Assessment of Dam Safety Coal Combustion Surface Impoundments (Task 3) Final Report

American Electric Power

Conesville
Generating Station

February 15, 2010

INSTRUMENTATION LOCATION PLAN
ASH POND COMPLEX
CONESVILLE POWER STATION
CONESVILLE, OHIO

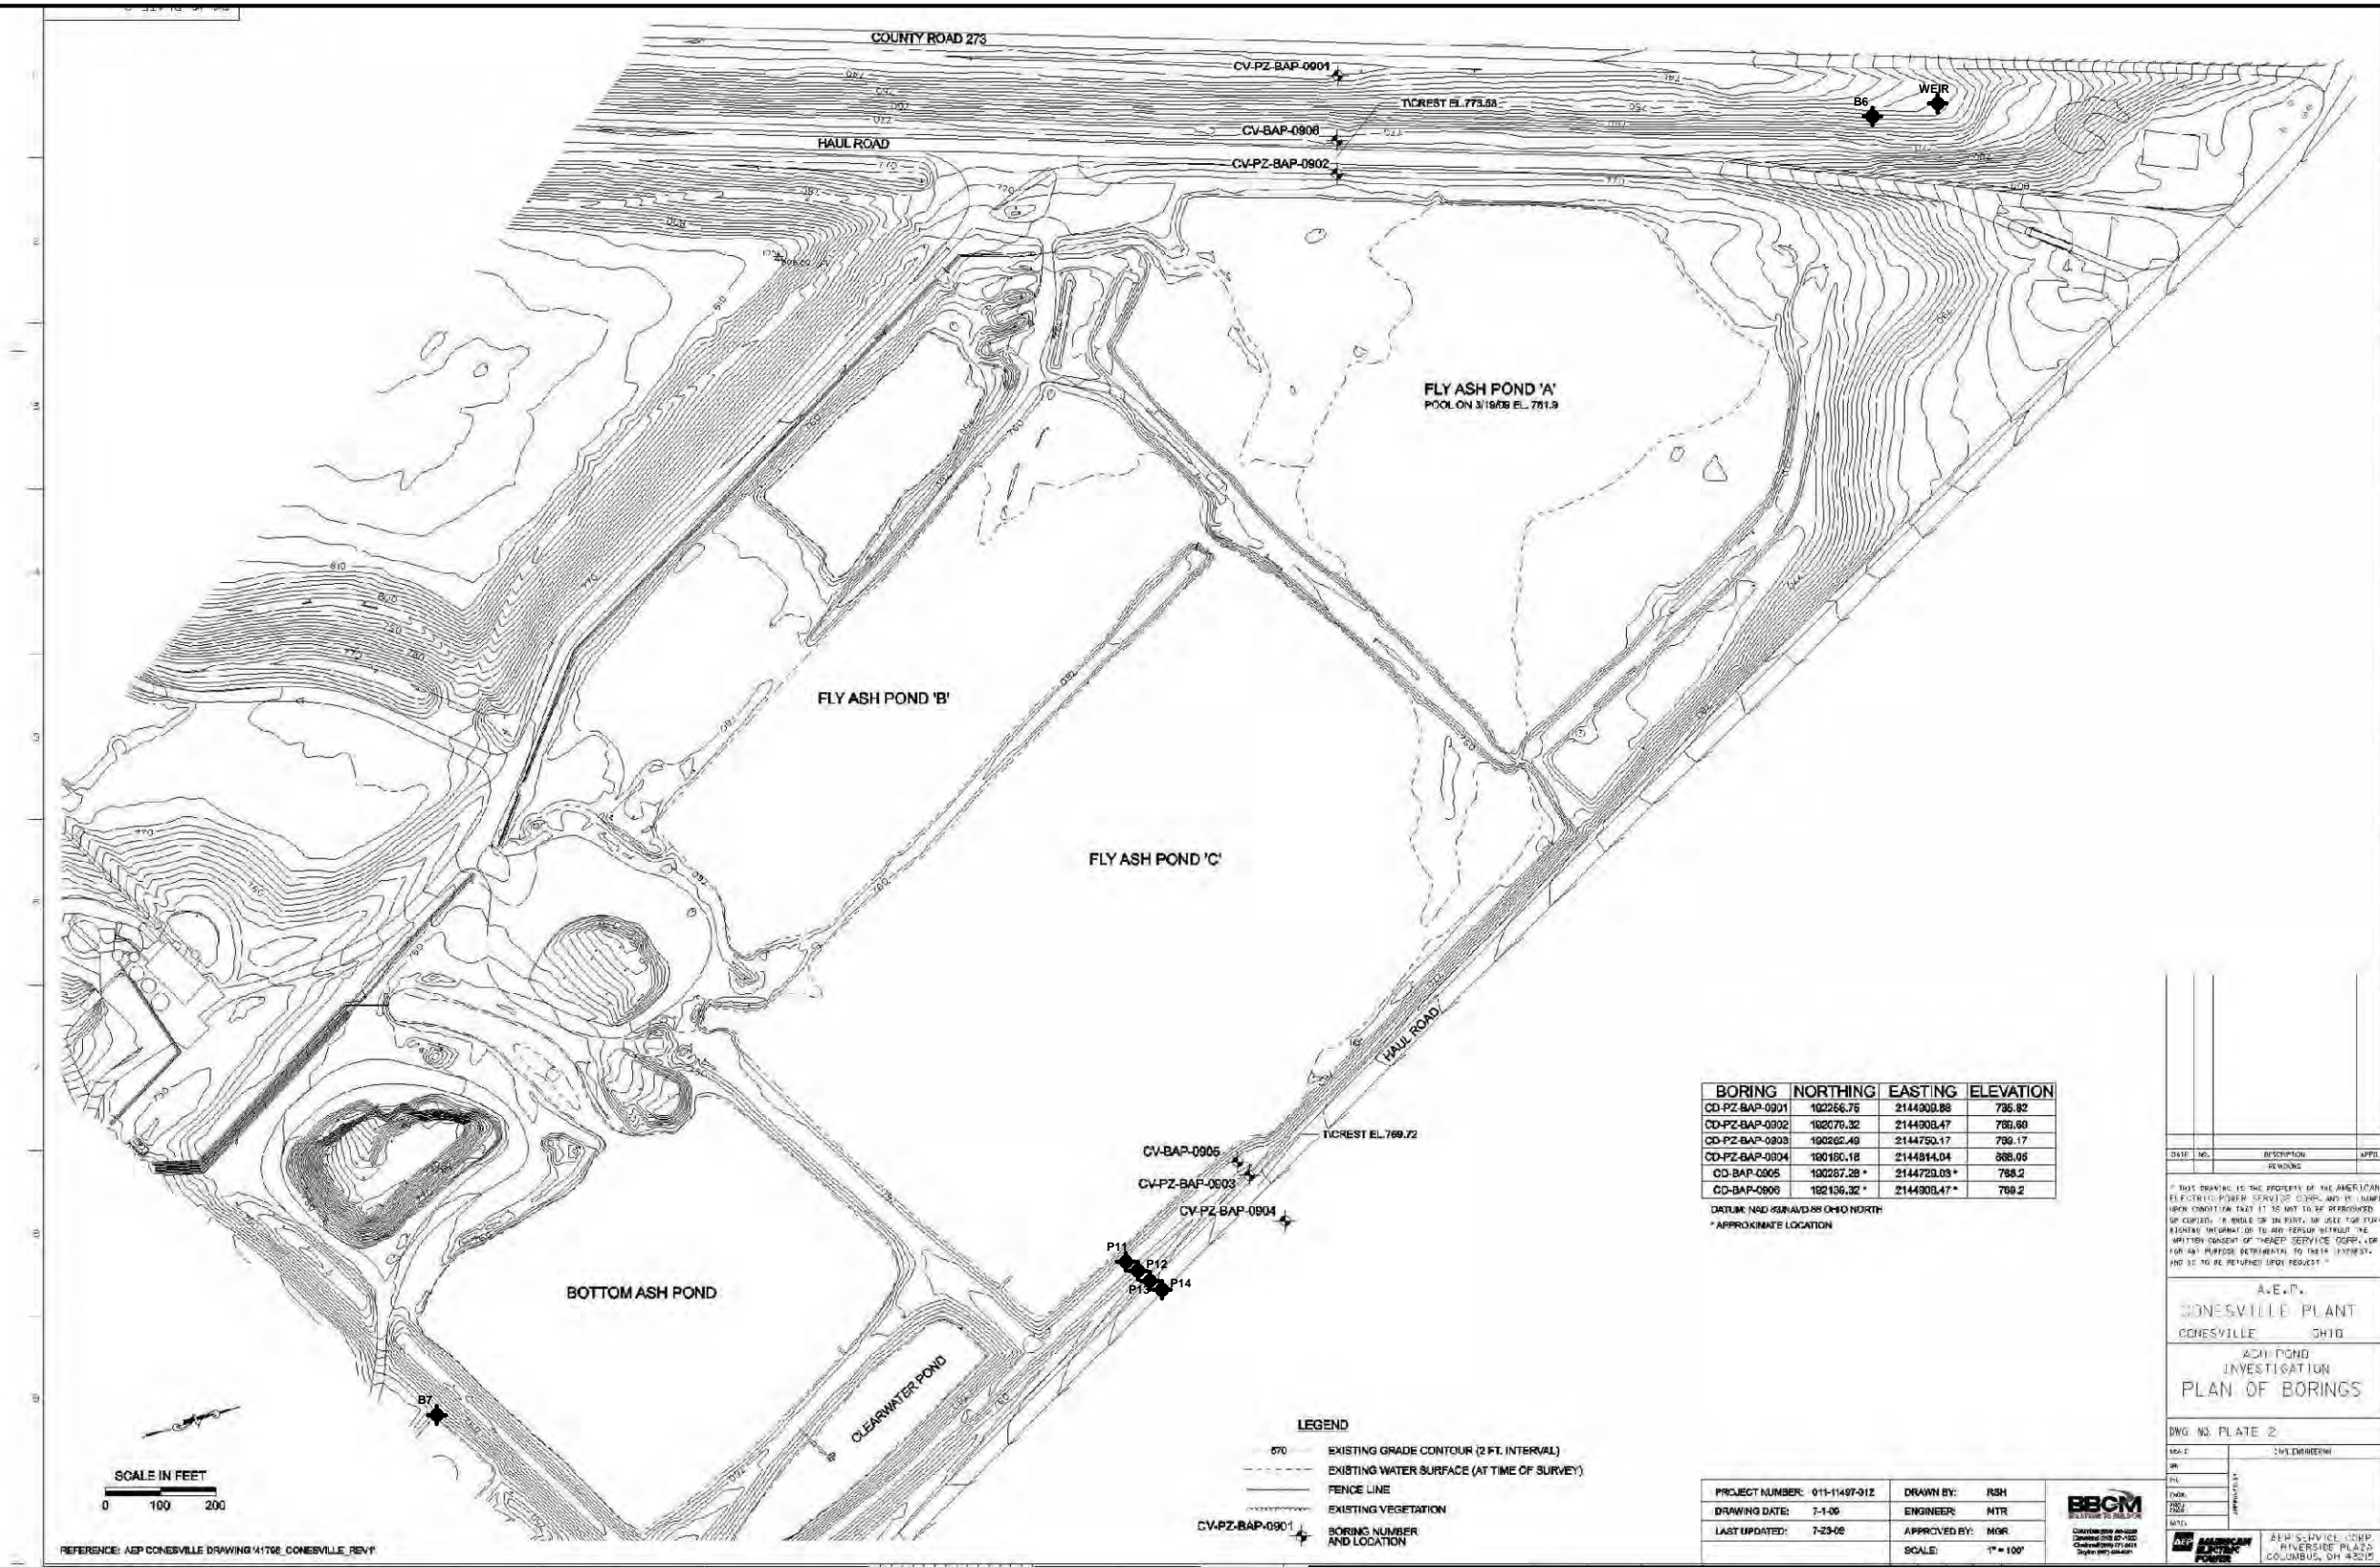
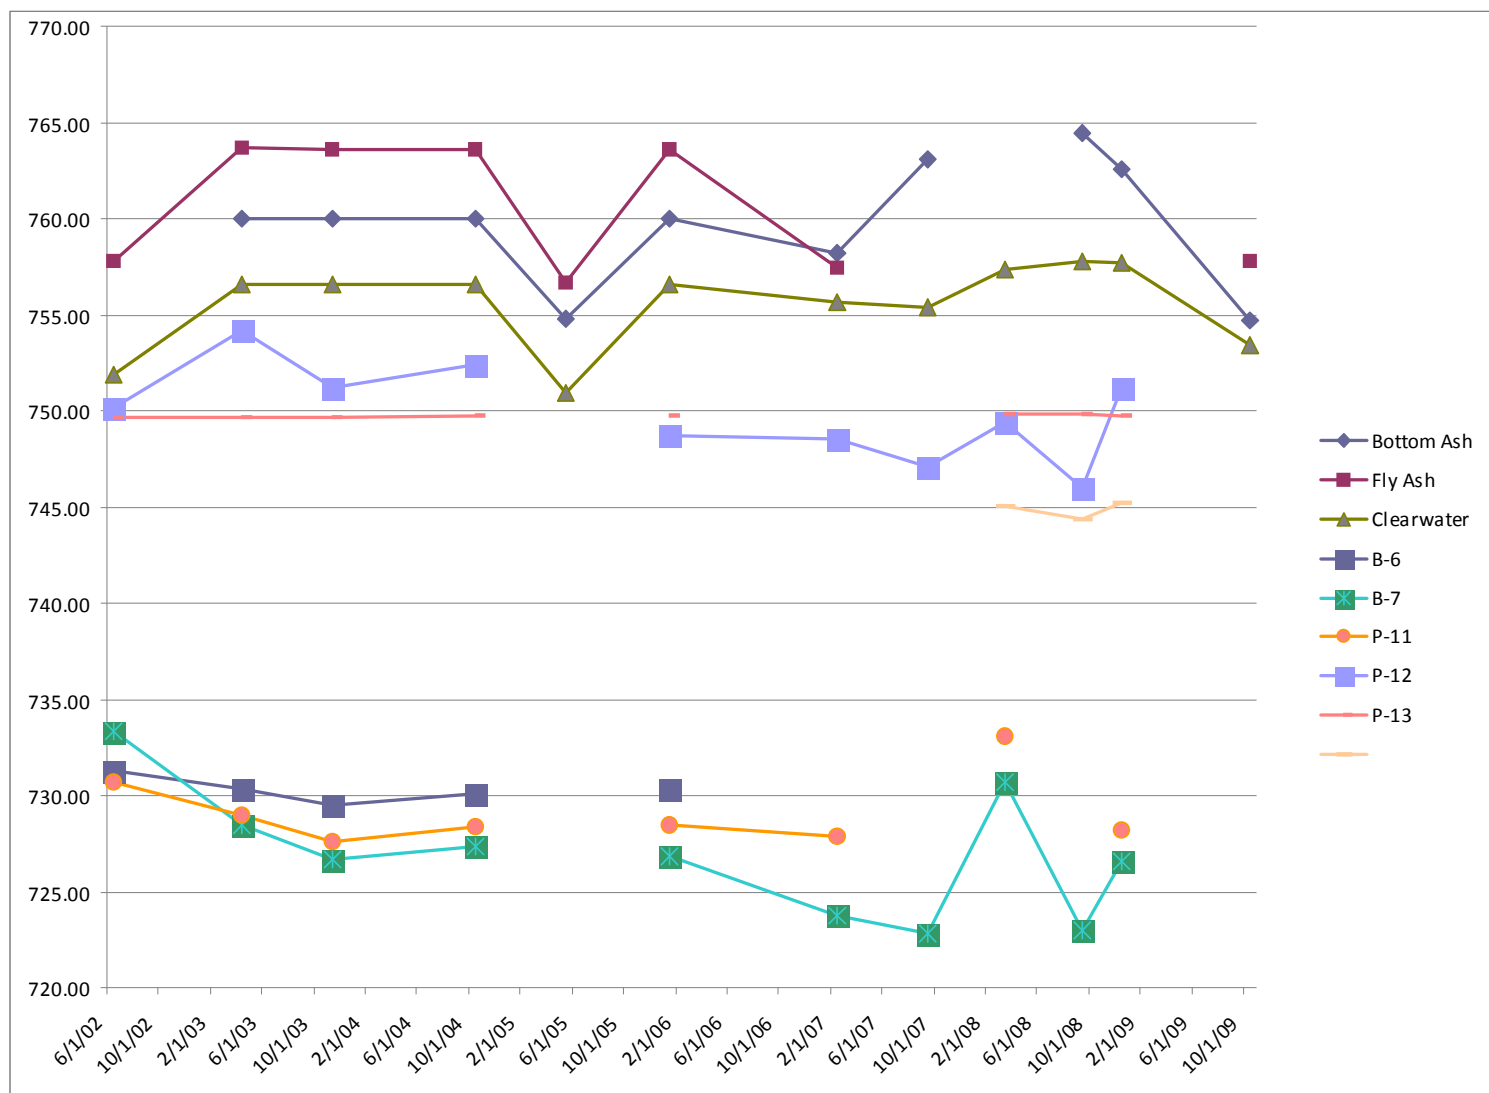
Plant personnel take readings in the piezometers and pond levels on a quarterly basis. We recommend that values be established as part of the OM&I manual for changes in instrumentation readings that warrant a review of the stability and pond operation.

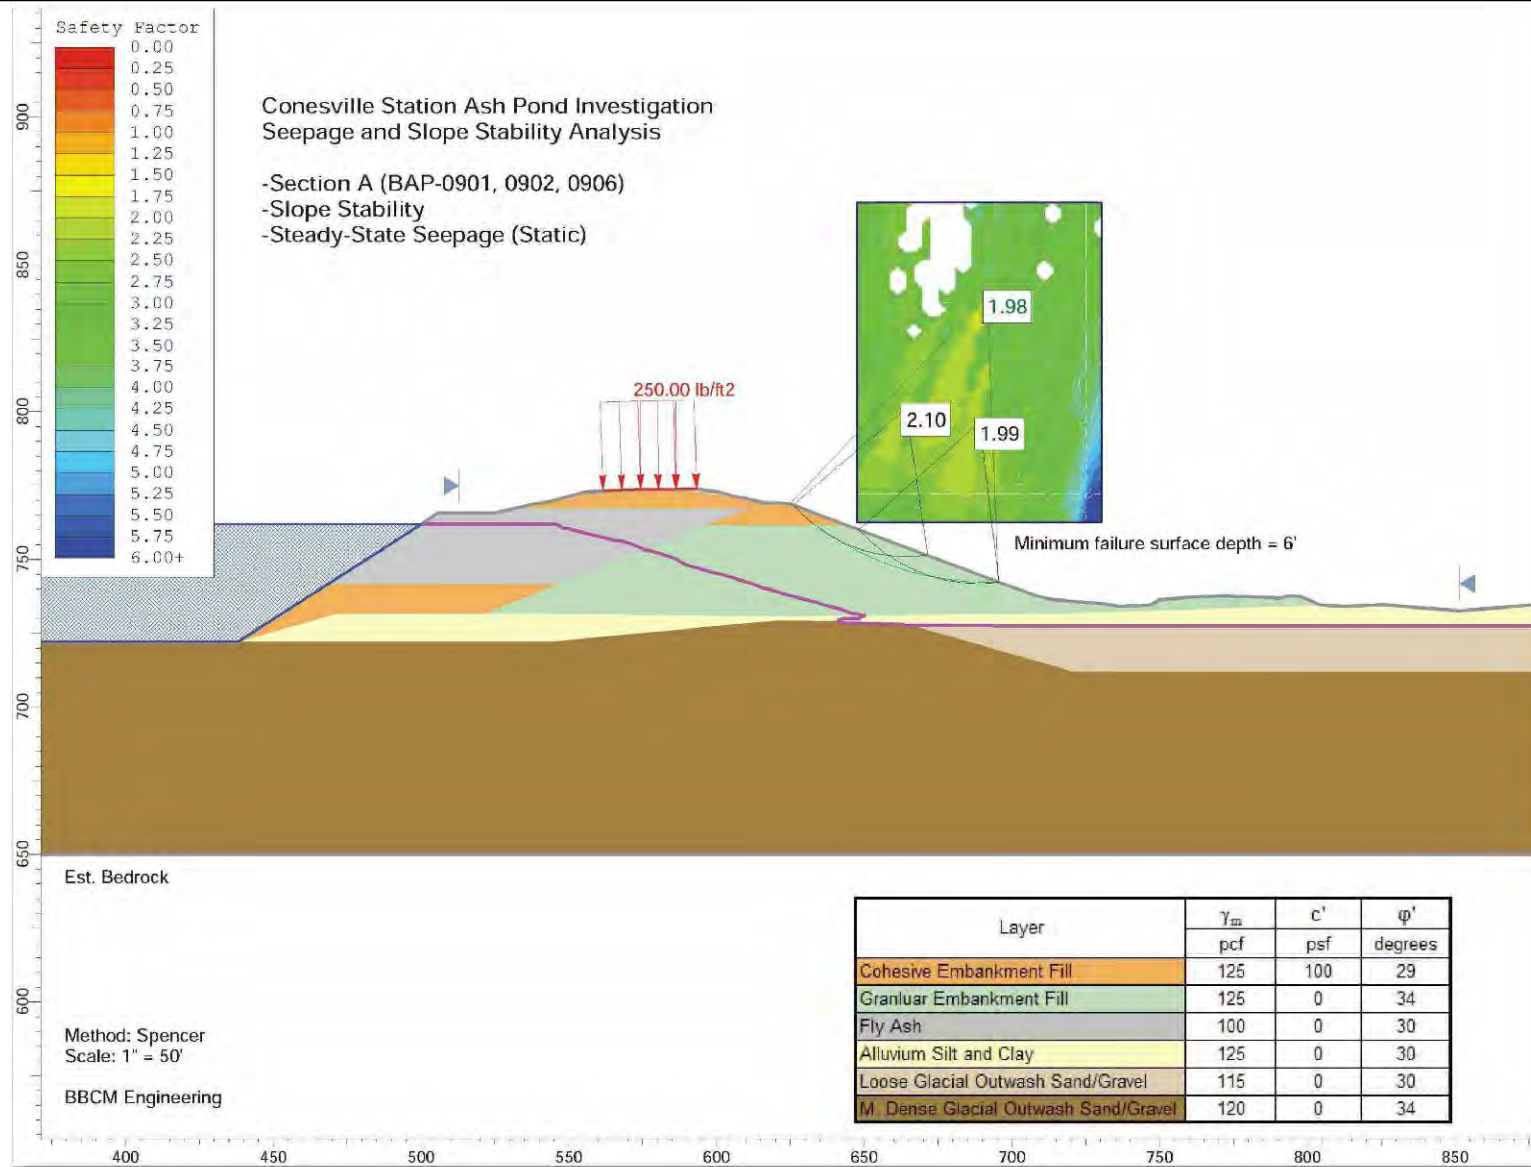
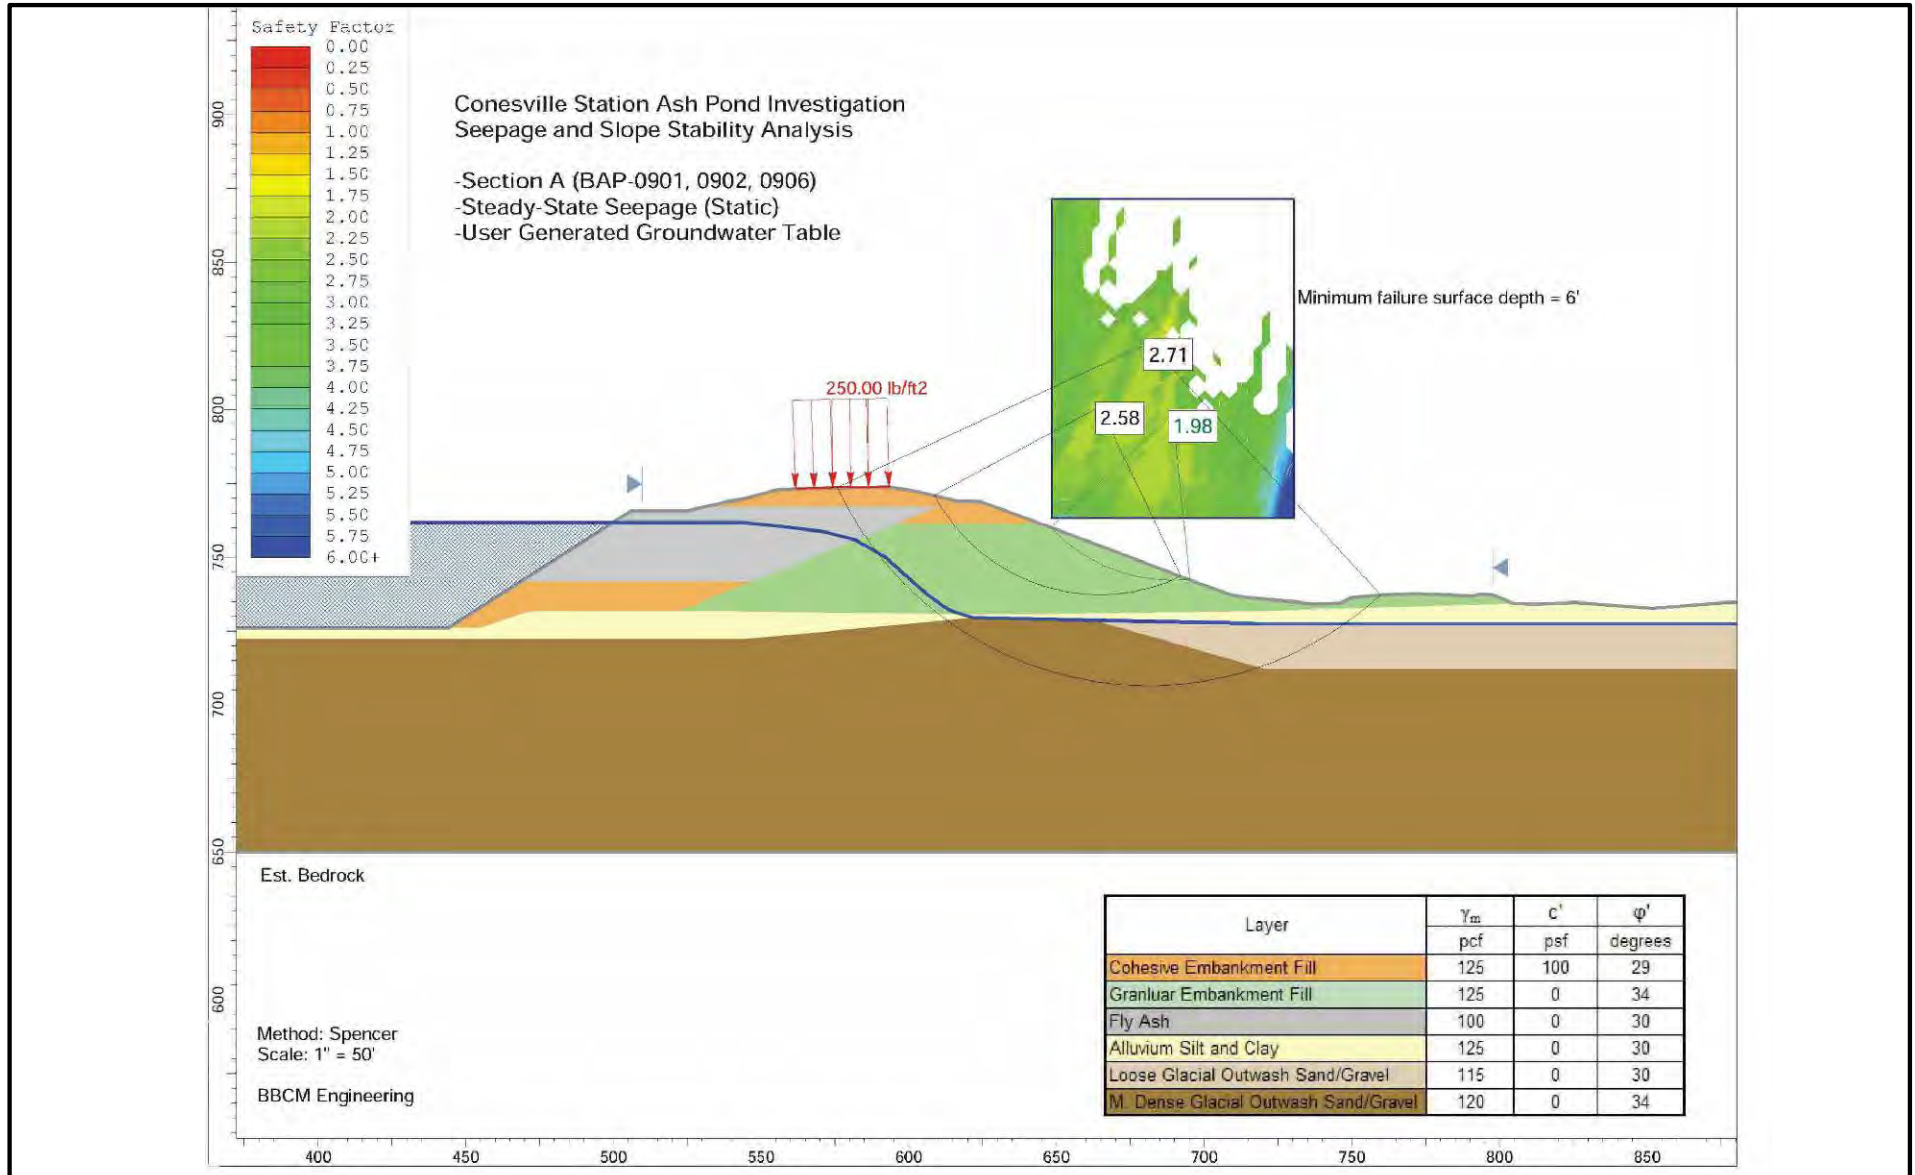
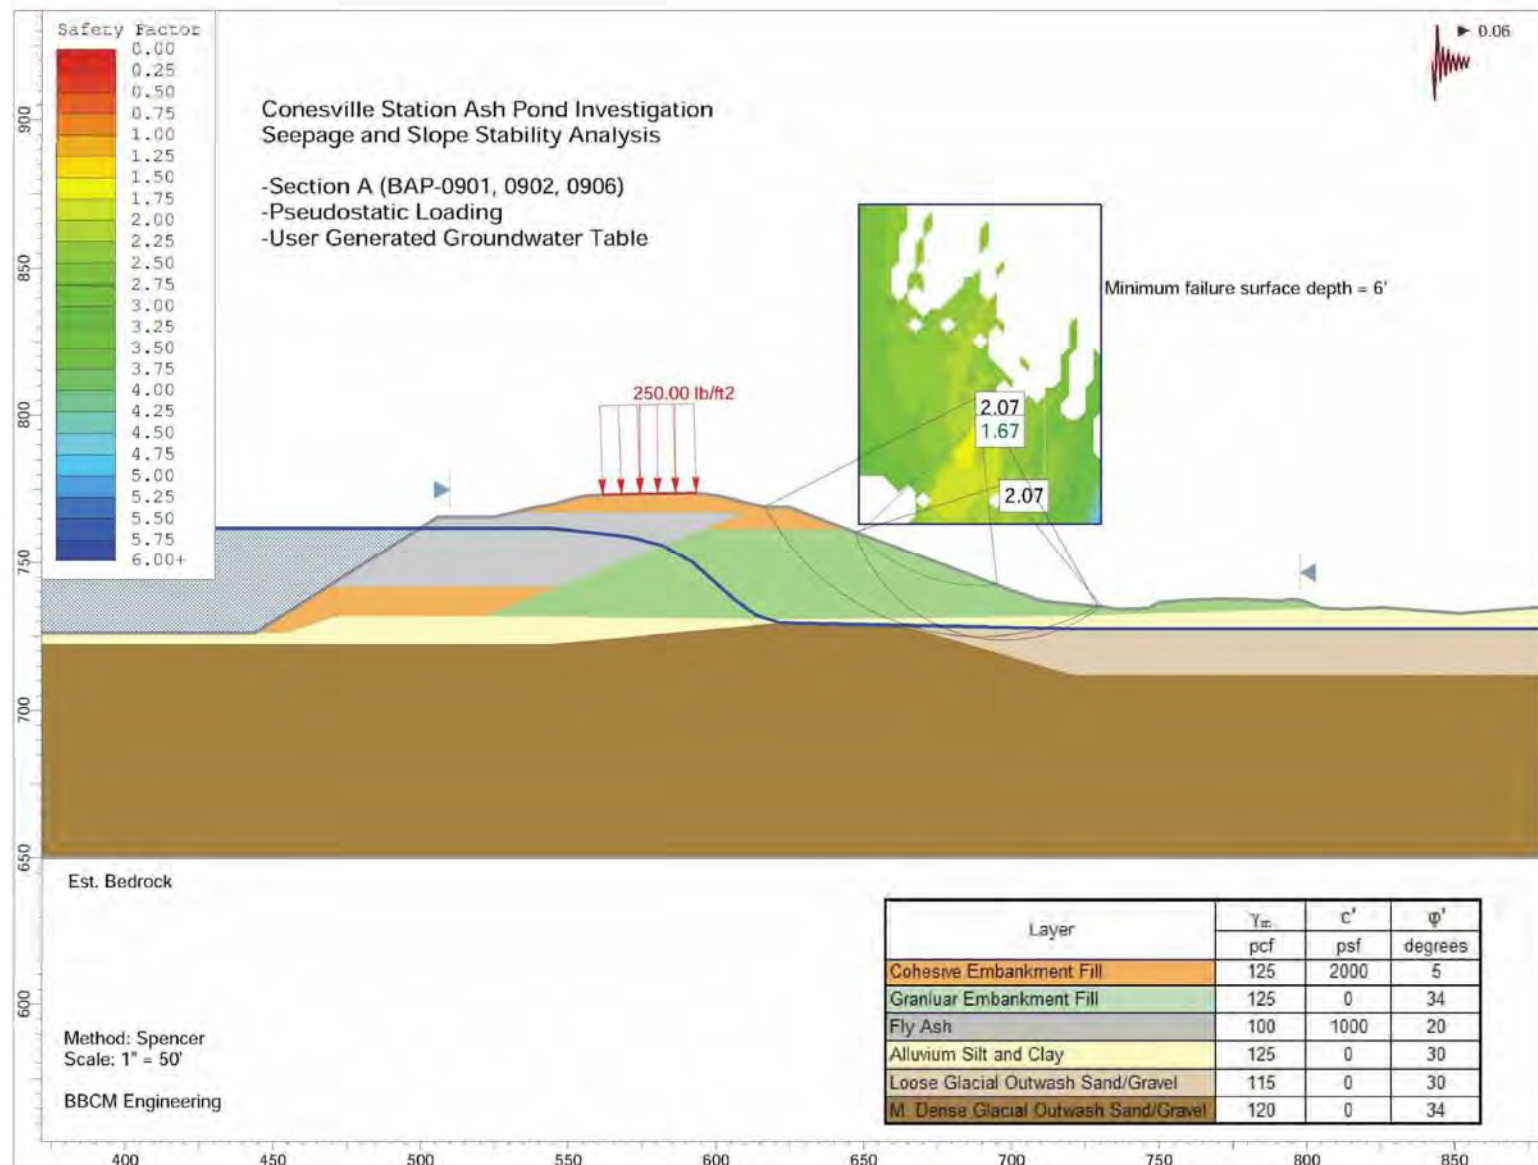
- The downstream slope stability outputs for the steady state load condition for Cross Section B show failure planes within the embankment soils. If the alluvium silt/clay was modeled with a soft layer at the depth corresponding to the low sample effort, a more critical failure plane may actually fall within the alluvium foundation soils and not the embankment soils.

- We recommend that an investigation be performed in which the properties of the alluvium silt/clay layer can be investigated in more detail in order to determine the presence and thickness of the soft layer of material indicated in the boring CV-PZ-BAP-0903. This scope of work should include additional laboratory testing of samples retrieved from the alluvium layer.
